## Technical Bulletin: Installation Action on ICM493-60A

All ICM493-60A models manufactured up to February 2026

Fig. 1

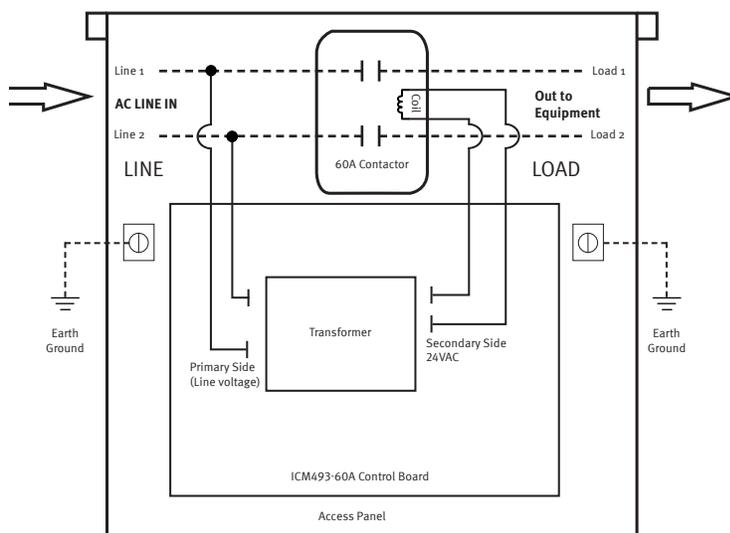
Regarding the ICM493-60A, the factory labeling for Line (L1/L2) and Load (T1/T2) connection is arbitrarily placed on the top of the contactor by the contactor manufacturer which could be opposite in orientation with respect to the ICM493-60A control board. The random contactor labeling could lead to confusion in wiring resulting in the inability of the ICM493-60A to power up. Since the contactor manufacturer's label orientation cannot be guaranteed, ICM Controls has created special labels on the ICM493-60A to clearly designate Line and Load connections to the contactor.

Effective February 2026, ICM Controls will clearly define both the Line and Load side of the ICM493-60A contactor with labels applied to the access door at the base of the contactor where the contactor is mounted to the door (see Fig. 1). In addition to this, ICM Controls will also update the wiring diagram and installation procedure in the install guide depicting the addition of these labels and the clarified wiring (Fig. 2).
